UNITED STATES PATENT AND TRADEMARK OFFICE

Office Action Summary

10/771,289

MEZIERE ET AL.

connected to the support element. See Belokin FIG2, as annotated by the Examiner, below.

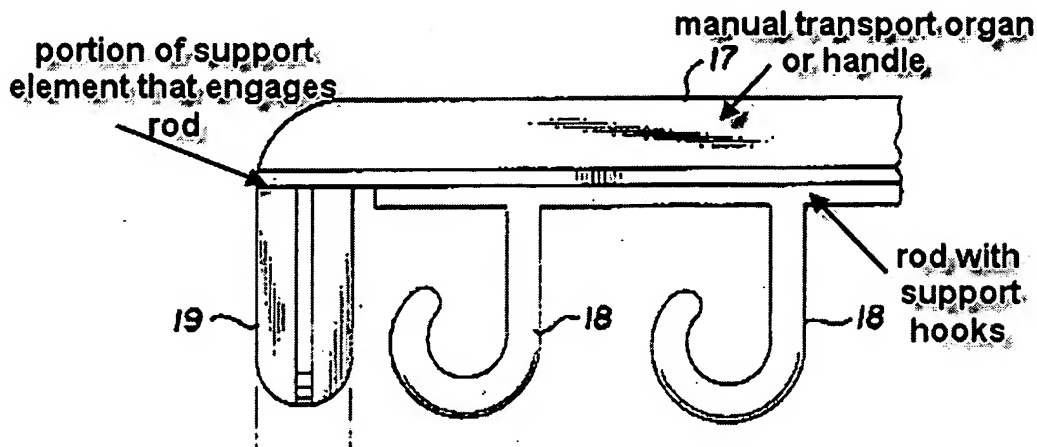
With regard to claims 8-13, 24, the support elements comprise a body or rod that carries a top section that may be used as a manual transport organ or handle to rotate the support elements or arms. The body or rod further comprises hooks 18 and is
